| APPLICATION NO. | FILING DATE | FIRST NAMED INVENTOR | ATTORNEY DOCKET NO. | CONFIRMATION NO. |
|-----------------|-------------|----------------------|---------------------|------------------|
| 10/787,269 | 02/25/2004 | Chien-Ping Huang | 58102-DIV (71987) | 5161 |

Office Action Summary

DETAILED ACTION

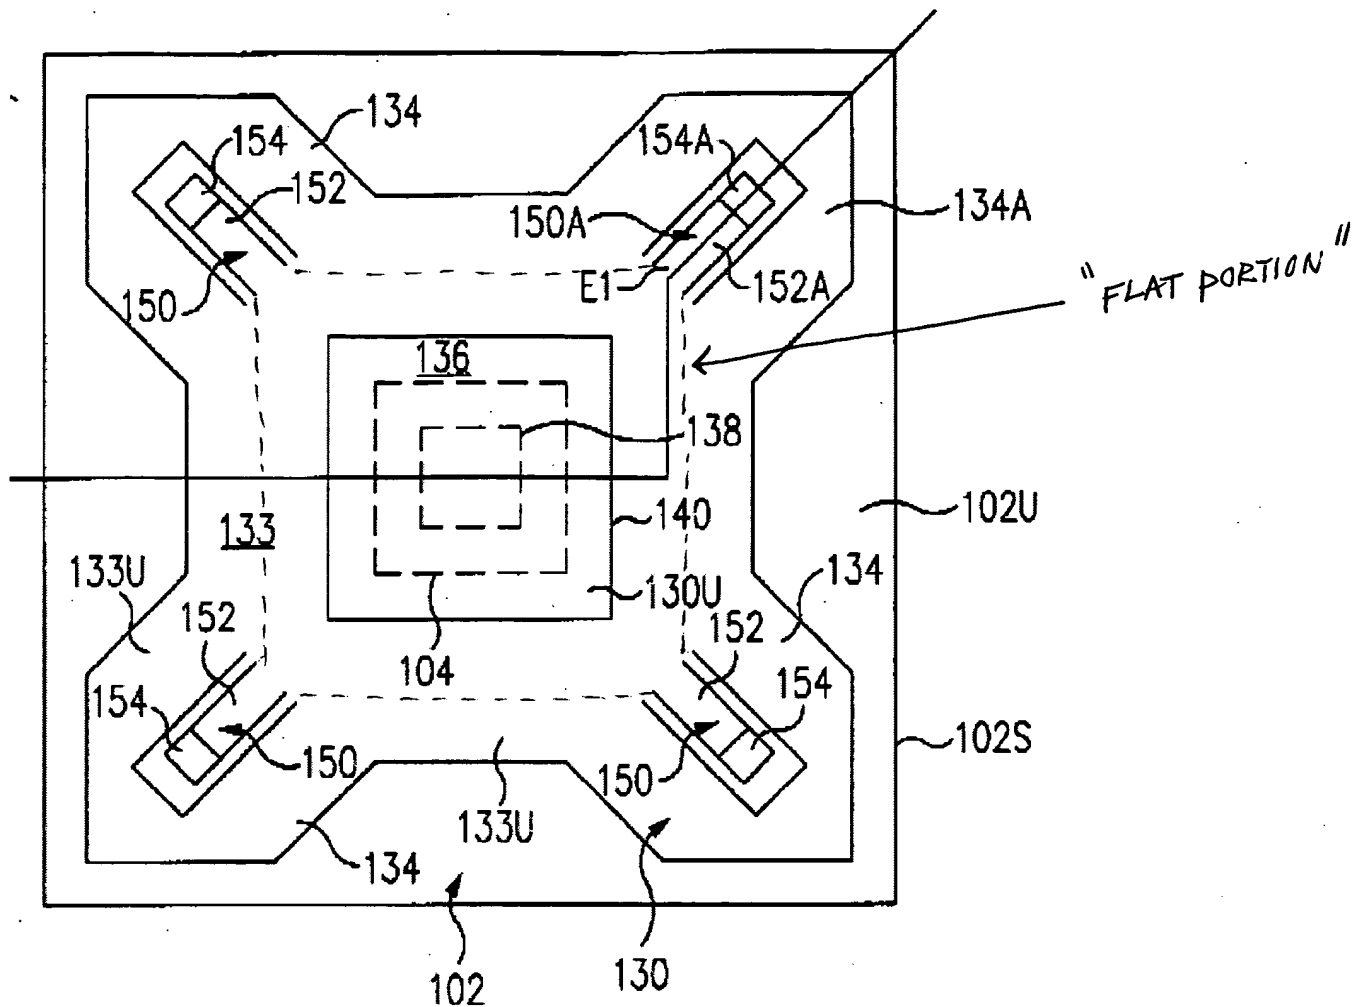
In Fig. 1 of Glenn, if the portion formed within the four support portions 152 is considered as "a flat portion" as claimed (see Fig. 1 below), then Glenn (Figs. 1-3) discloses a heat dissipating structure for a semiconductor package 100 having a plurality of bonding wires 112, comprising: a flat portion having a top surface and a bottom surface opposed to the top surface, wherein at least a peripherally-situated recess 140 is formed on the top surface of the flat portion; and a plurality of support portions 152 formed at edge corners of the bottom surface of the flat portion (Fig. 1), wherein the support portions 152 are arranged to form a space between two adjacent support portions 152, and the space is dimensioned to have a predetermined height larger than a height of wire loops of the bonding wires 112 (see Fig. 3).

Regarding claims 35-37 and 43-45, Glenn further discloses that each of the support portions 152 has one end E1 attached to the flat portion and the other end E2 formed with a contact portion 154A (see Figs. 1 and 2), the contact portion 154A extends laterally with respect to the flat portion and has a rectangular shape (see Fig. 1).

Regarding claims 16 and 19, in Fig. 1 of Glenn, if the portion formed within the four support portions 152 is considered as "a flat portion" as claimed, then Glenn (Figs. 1-3) discloses a heat dissipating structure for a semiconductor package 100 having a substrate 102, a chip 104 mounted on the substrate and electrically connected to the substrate via a plurality of conductive elements 112, the heat dissipating structure comprising: a flat portion, wherein at least a peripherally-situated recess 140 is formed on a top surface of the flat portion; and a plurality of support portions 152 formed at edge corners of the flat portion for supporting the flat portion in position above the chip (see Fig. 1), wherein the support portions 152 are mounted at a predetermined area on the substrate 102 and free of interference with an arrangement of the chip 104 and the conductive elements 112, and the support portions 152 are arranged to form a space between two adjacent support portions 152, the space being sufficient dimensioned to accommodate the conductive elements 112.

Regarding claims 20-23, Glenn further discloses that: the support portions 152 are situated at edge corners of the flat portion (Fig. 1), the flat portion has a top surface 130U exposed to outside of the encapsulant 160 (Fig. 2) and a bottom surface being

Regarding claims 26-28, Glenn further discloses that each of the support portions 152 is formed with a contact portion 154 at a position in contact with the substrate 102, the contact portion 154 extends laterally with respect to the substrate 102 and has a rectangular shape (Fig. 1).

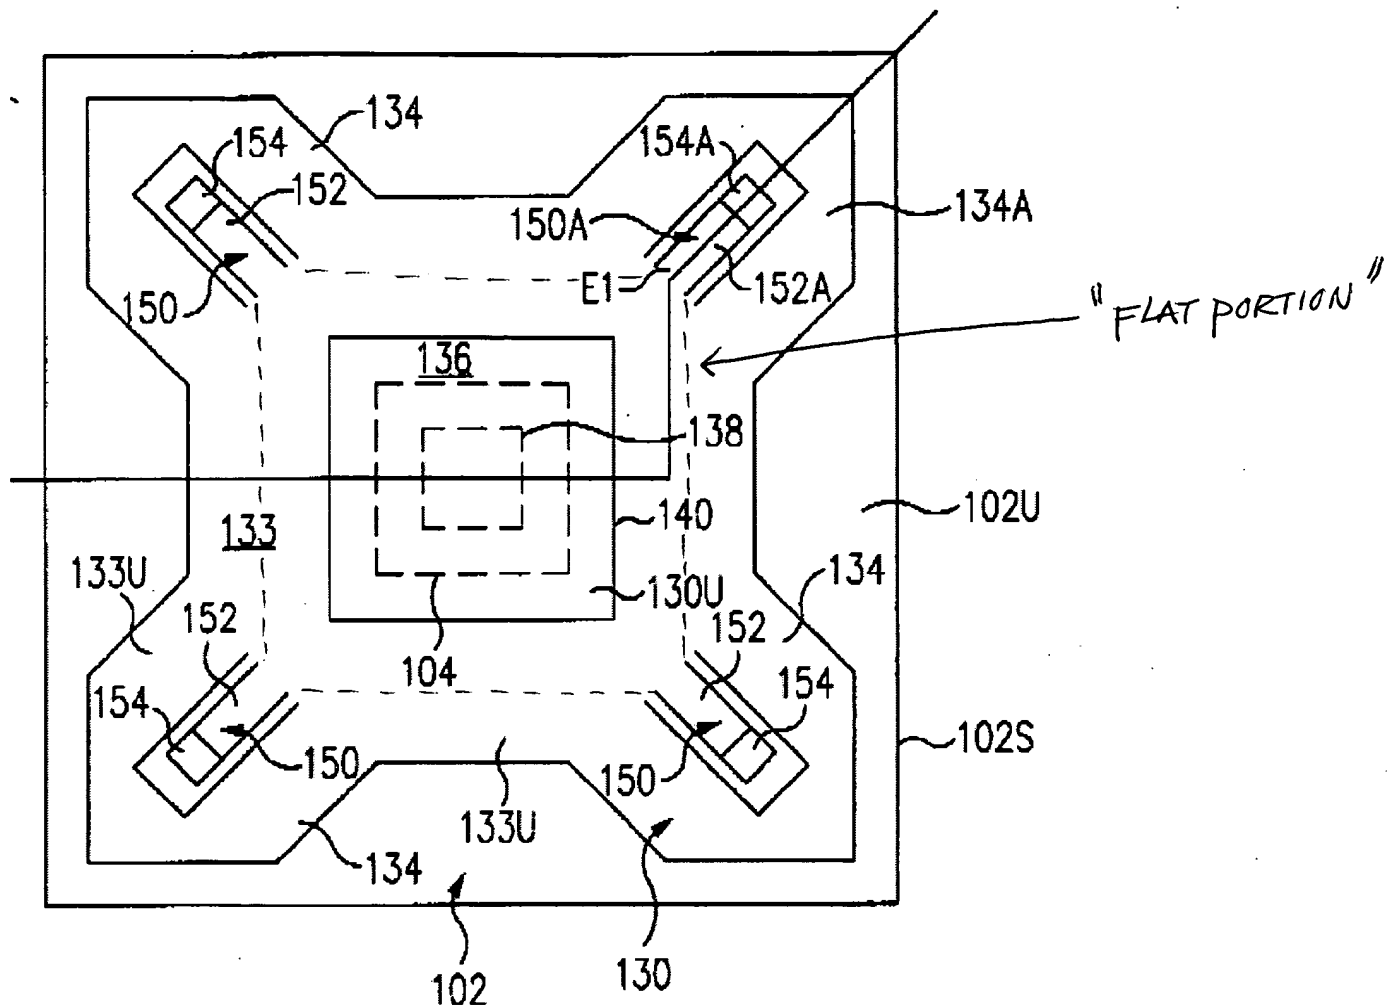
6. Applicant argues that the support portions 152 shown in Fig. 1 of Glenn are not formed at the edge corners of the flat portion of the heat sink.

This argument is not persuasive because if the portion formed within the four support portions 152 is interpreted as "a flat portion" as claimed, then the four support portions 152 are formed at four edge corners of the flat portion (see Fig. 1 below)
